TSB # 16-2015

TO: All Bourgault Dealers
ATTN: Service Manager, Parts Manager, Sales Manager
SUBJECT: Digi-Star Weigh Scales – LO BATT Repair

FIX ON FAILURE (Failure Code 16.15)

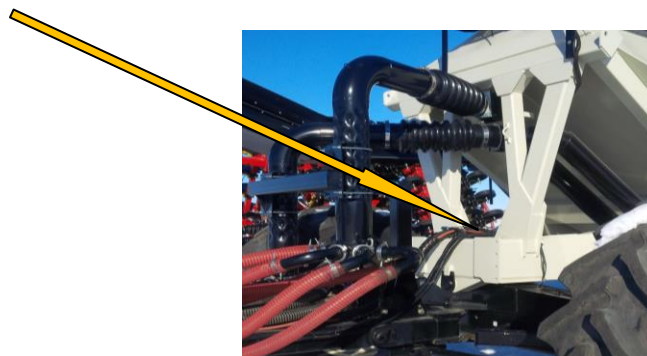
- For any scales experiencing the LO BATT error follow the instructions to fix.
1. Remove power supply cable from Drive 5 on MDECU – free up the power supply cable by cutting the cable ties back to the Digi-Star indicator.

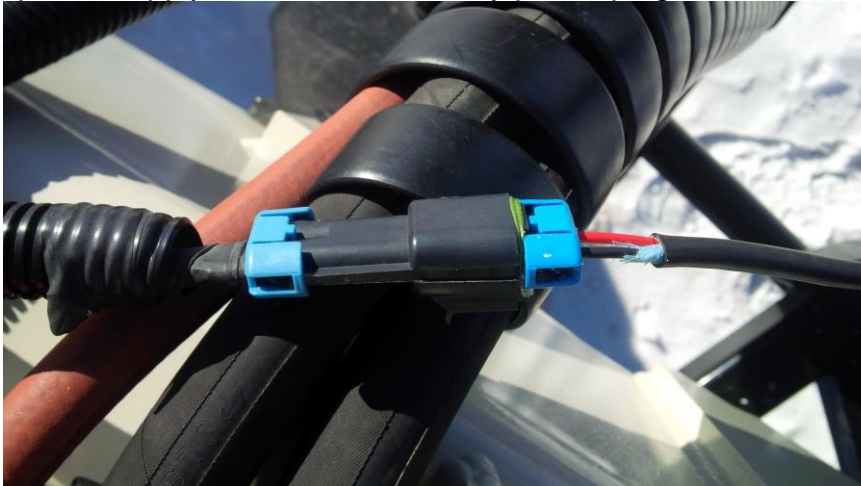
3. Remove the end from the Power supply cable and replace it with a 2 pin female metri-pak connector. Bourgaault part number 3150-48.
